NOTICE TO PROCEED

Project: Grand Junction Fire Department Fire Station #3 Construction
IFB-4889-21-DH

Project:
Grand Junction Fire Department
Fire Station #3
GMP Estimate

A2-2

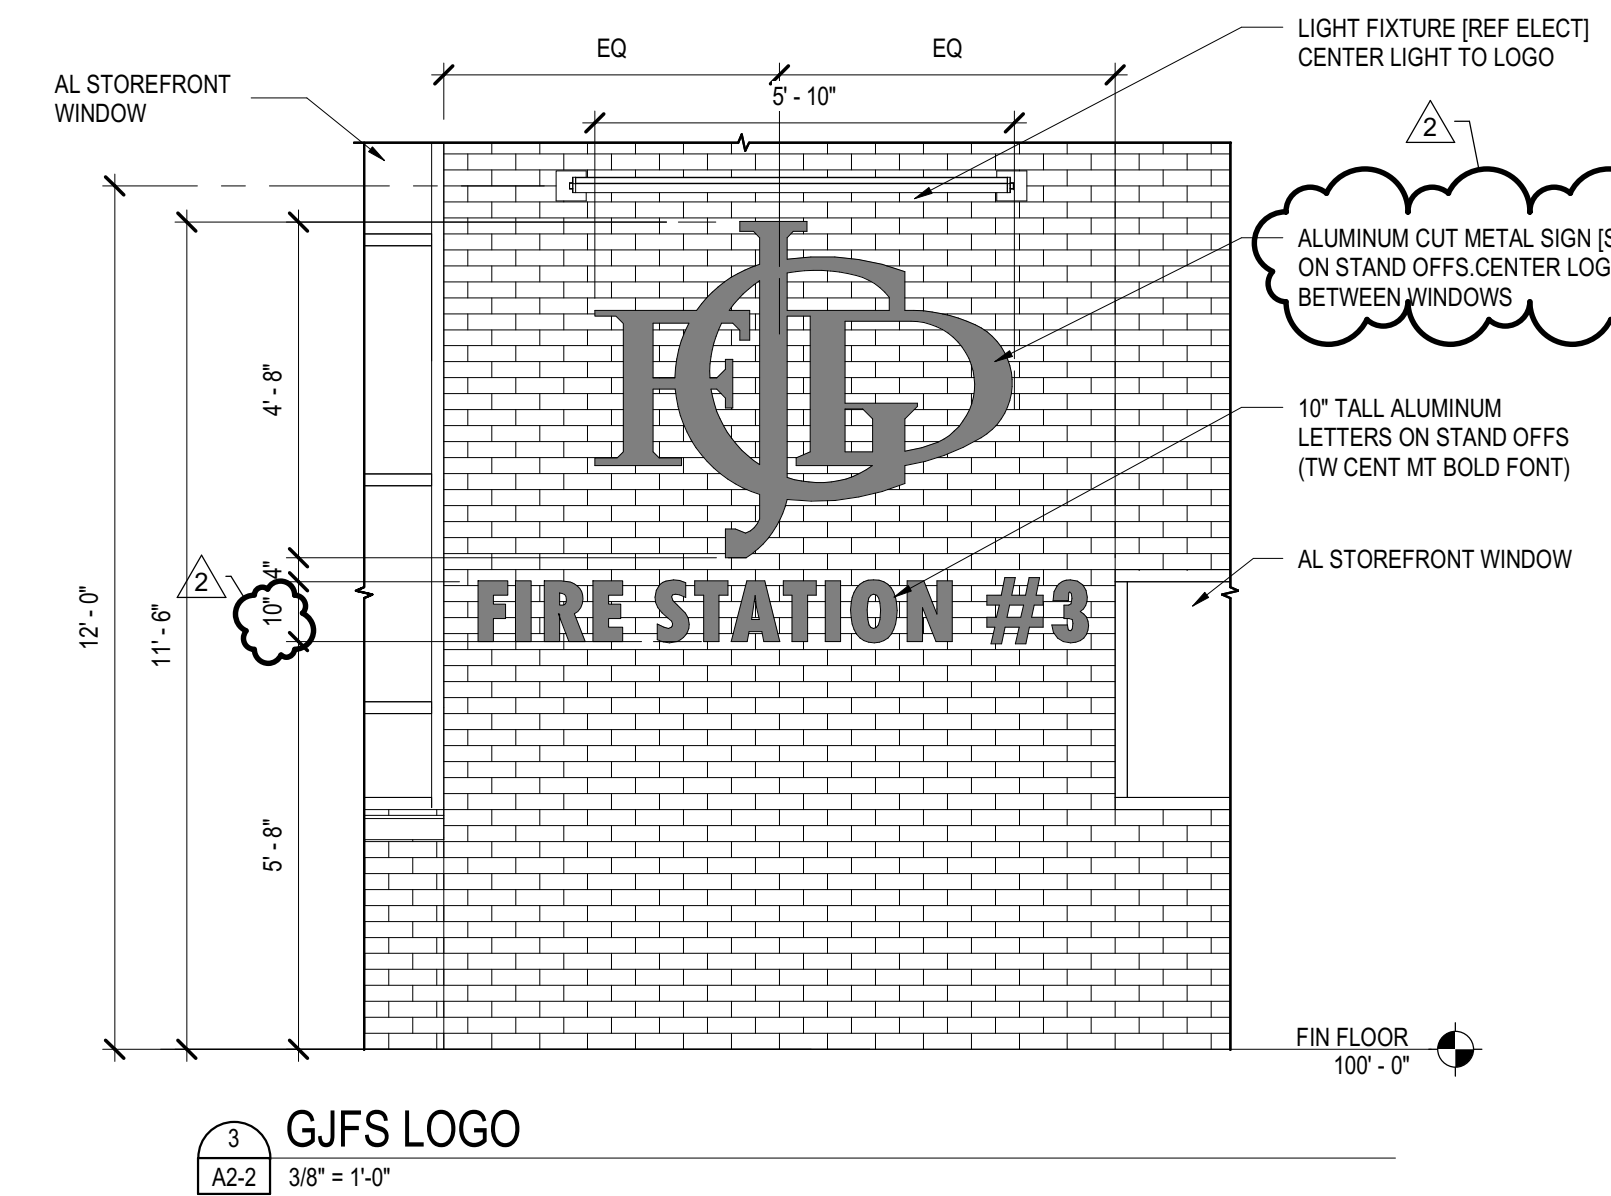
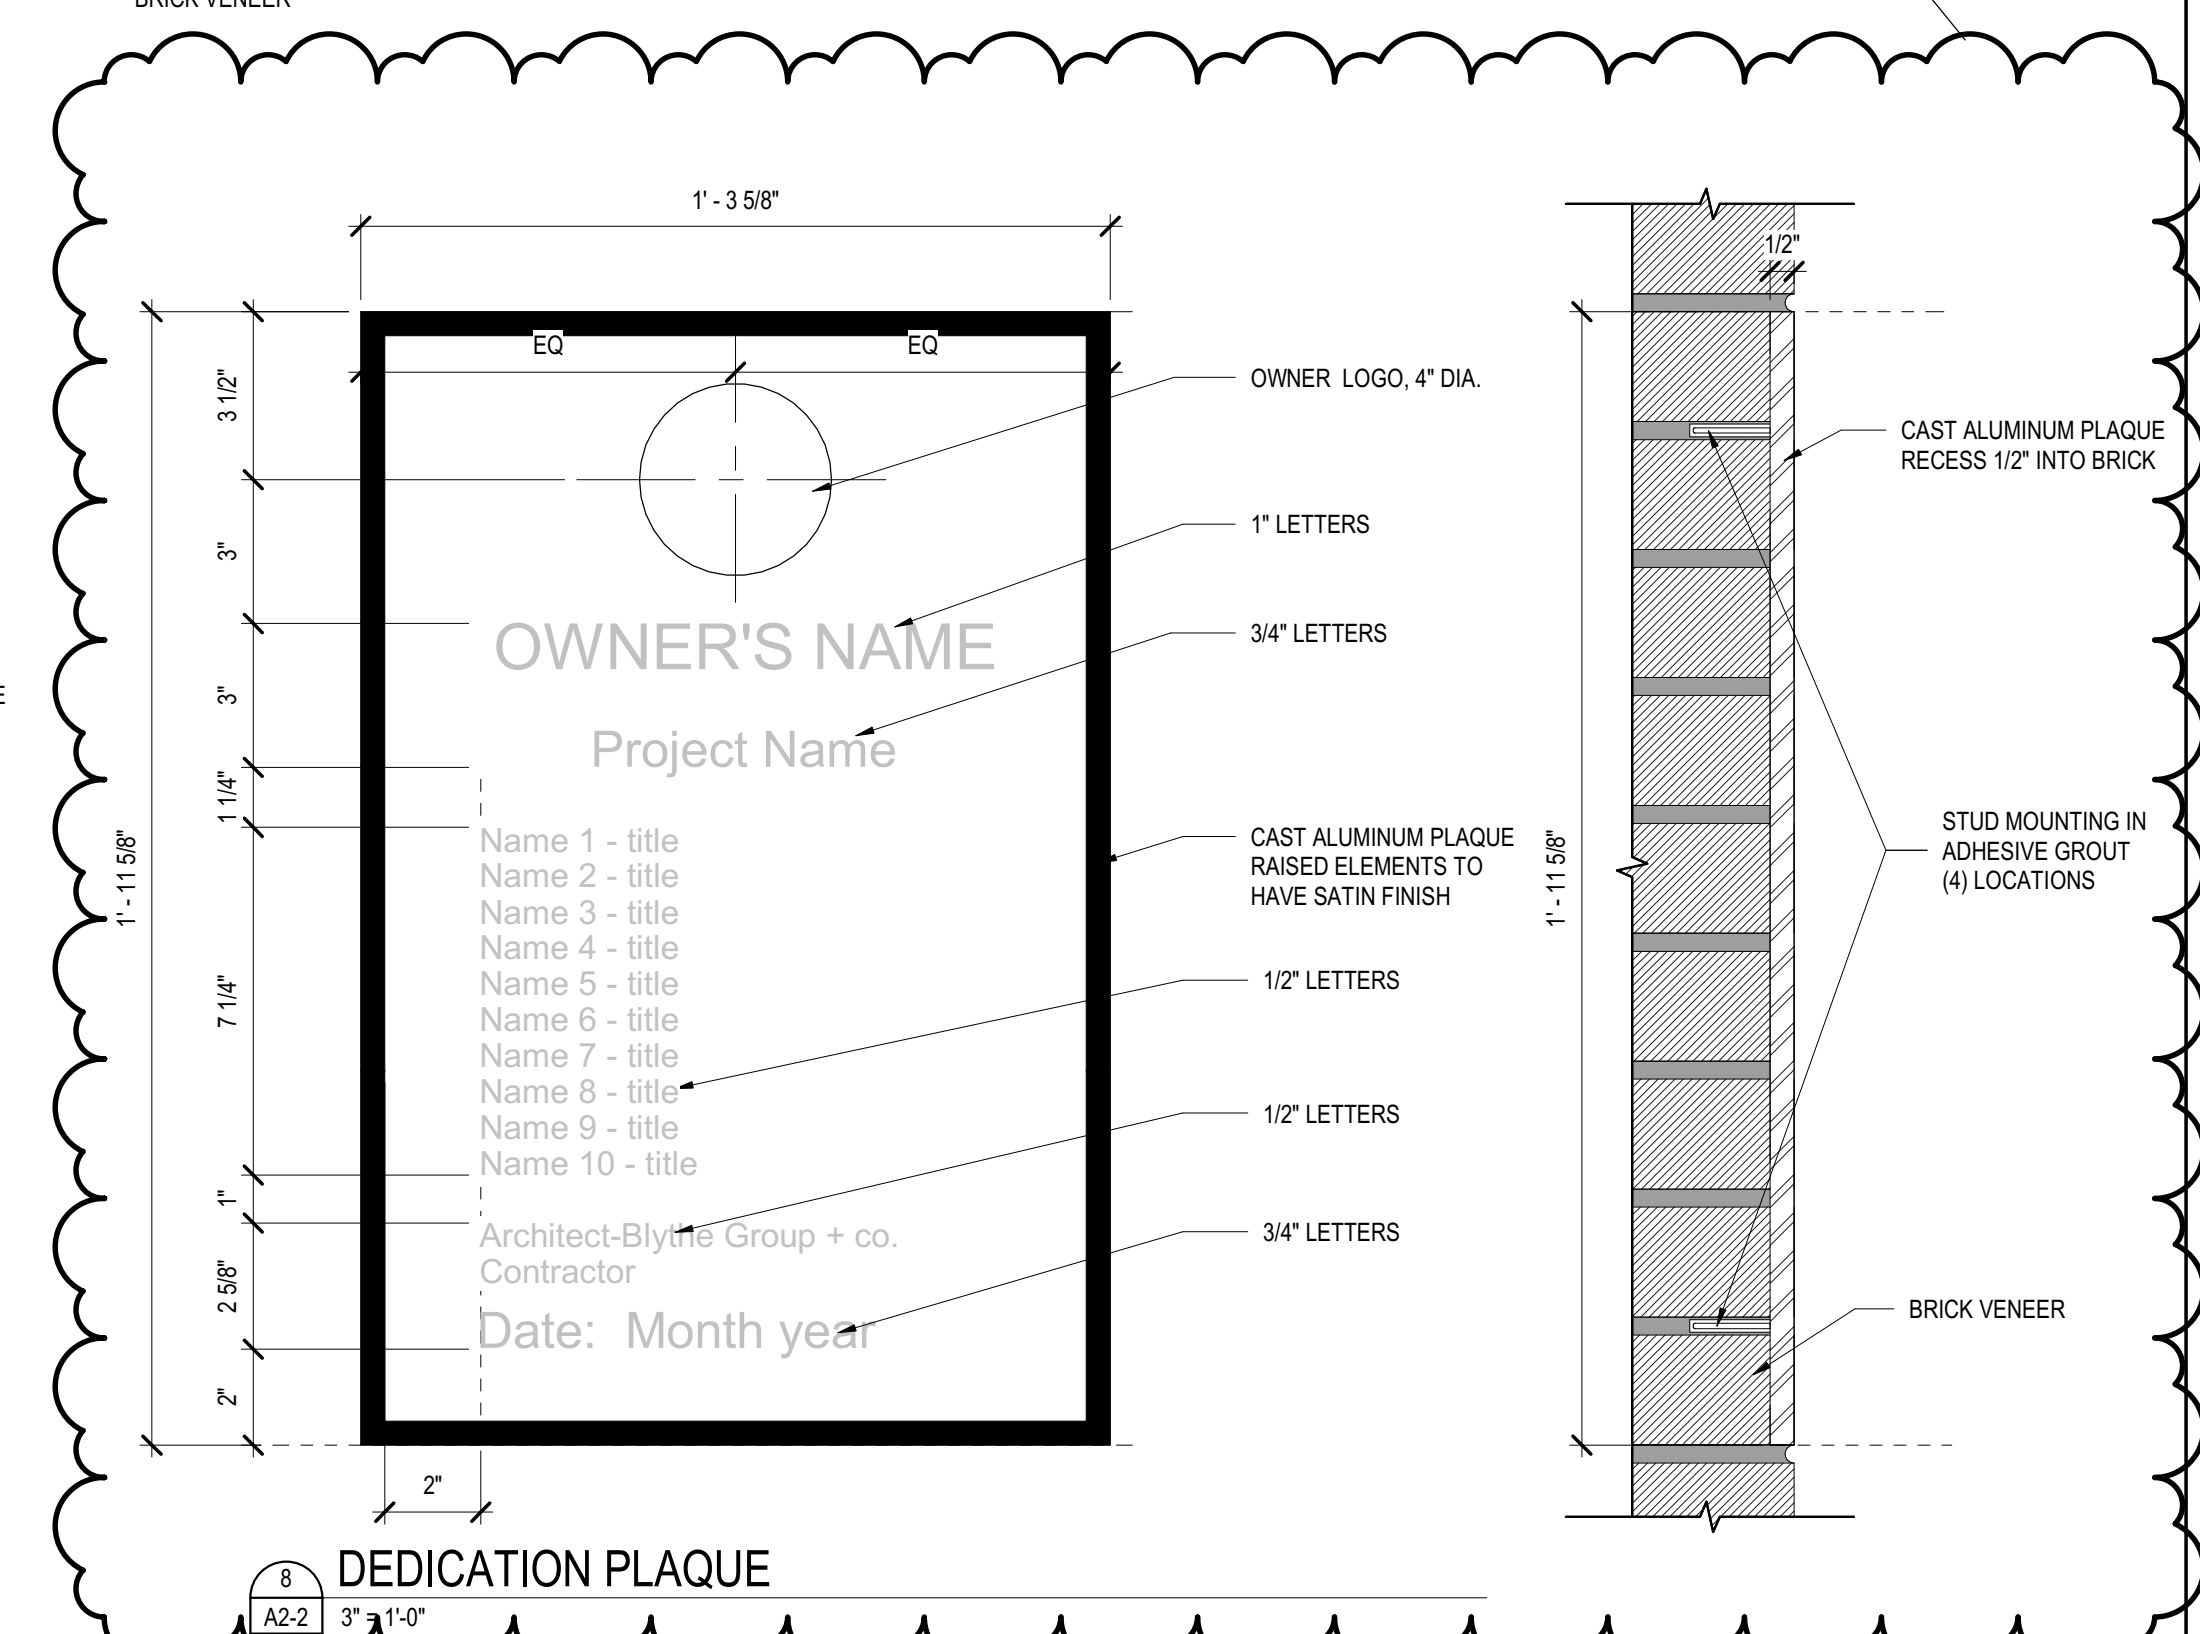
19. Drawing 2/A2-2: Please provide dimensions and specs for the "3" on the hose tower.
- A. Revise section 10 14 00 - Signage to include or revise requirements for sign on hose tower, dedication plaque, and cut metal letters. Refer to attached revised section and revised Sheet A2-2.
